ADDENDUM NO. 1

**Woodlands Street Paving – RFP 2021-004
PID: CIPTR-2022A**

2022 STREET REHAB PROGRAM
WOODLANDS NEIGHBORHOOD

SHEET NO.
C02

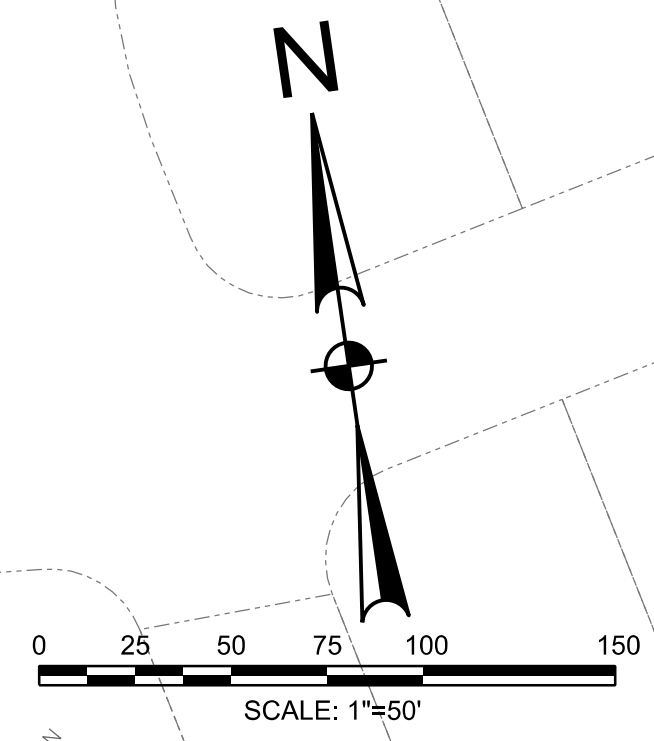
NO.	DESCRIPTION	DATE	ID
1	changed pavement thickness to 2"	4/6/2022	eb

1. **Bonds**: No Change
2. **Dates**: No Change
3. **Questions and Answers**: This Bid Addendum also answers questions posed by contractors throughout the bid process and at the pre-bid meeting as follows:
 - a. *Question from Bidder. See CivCast*
 - a. Answer.
4. **Bid Document Changes**: This item outlines changes to the Bid Documents:
 - a) This addendum revises the pavement thickness from 1.5” to 2” thick HMAC TYPE “D”
